Discussion.

Fig. 7.

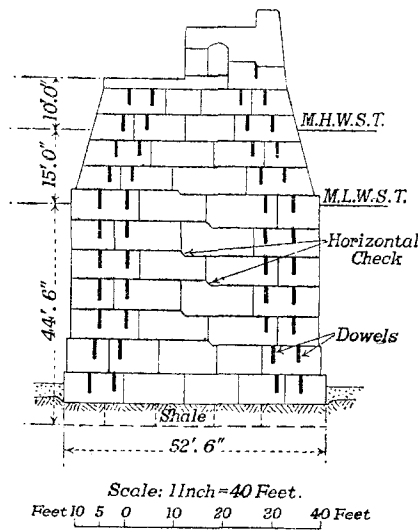
Mr. N. G. GEDYE remarked that the breakwater at Antofagasta described in the Appendix to the Paper was built of horizontal coursed blocks, and he thought that those blocks had no bond or key in the horizontal planes. When Sir John Wolfe Barry and Sir William Matthews reconstructed the outer half of the North Pier at Tynemouth¹ between 1901 and 1908 they introduced a measure of horizontal bonding of the coursed blocks which he believed was then novel and of which he thought the Tyne Pier was the first example (*Fig. 7*). A check, 6 inches high, extending practically from end to end of the work, was provided in each course of blocks below low water, with the object of preventing the sliding of one course of blocks over the course immediately below it. The blocks above low water were set with cement joints and beds. He would like to know whether, in the Authors' opinion, if the breakwater at Antofagasta had had the courses bonded as in the Tyne Pier, the disaster would have occurred. As to the depth to which sea-action extended, the North Pier at Tynemouth was constructed in a depth of approximately 35 feet at low water of spring tides, or about 50 feet at high water. In making an examination of the pier in diving-dress about

the year 1911 he had walked round the breakwater head and had found on the sea-bed, a few feet away from the wall, a number of large photographic plates, most of them undamaged, some of which he had recovered. They had been identified as plates used by the resident engineer on the work and thrown overboard when the work was finished, 3 or 4 years before he discovered them. His observations of the piers at the mouth of the Tyne showed that at a depth of 35 feet below low water there was no serious wave-action. The difference between the waves on the Pacific coast of South America, as at Valparaiso, and those on the east coast of England and Scotland,

to which Mr. Wilson had referred, might be due to the difference in the depth of water near the shore. The waves that rose against the face of the outer part of the breakwater at Valparaiso in a great depth of water were almost waves of pure oscillation, whereas on the shallower east coast of England and Scotland the waves were, he thought, largely waves of translation, even in the comparatively deep waters at Peterhead or at the mouth of the Tyne.
